UNITED STATES
DEPARTMENT OF THE INTERIOR
BUREAU OF LAND MANAGEMENT

FORM APPROVED
OMB NO. 1004-0137
Expires: January 31, 2018**SUNDRY NOTICES AND REPORTS ON WELLS**
Do not use this form for proposals to drill or to re-enter an abandoned well. Use form 3160-3 (APD) for such proposals.5. Lease Serial No.
- NMNM06293

☐ Oil Well ☒ Gas Well ☐ Other8. Well Name and No.
INDIAN HILLS UNIT 17

Permanent Abandonment of Federal Wells
Conditions of Approval

OXY USA WTP LP - Proposed
Indian Hills Unit #17
API No. 30-015-30661

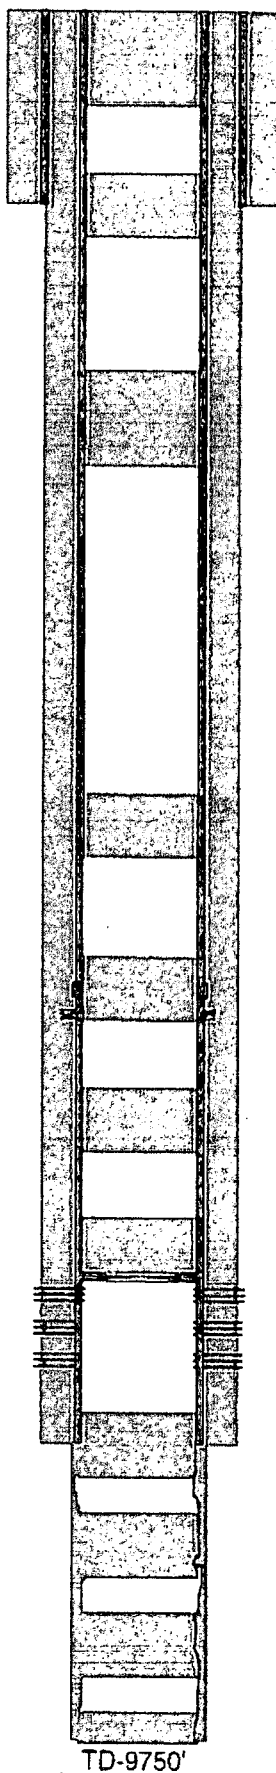
2. M&P 35sx cmt @ 6740-6540' WOC-Tag

7. M&P 150sx cmt @ 750' to surface 800 - Surf

**** BLM REVISED ** BLM REVISED ** BLM REVISED ** BLM REVISED ** BLM REVISED ****

150sx @ 750'-Surface

35sx @ 6710-6540' WOC-Tag
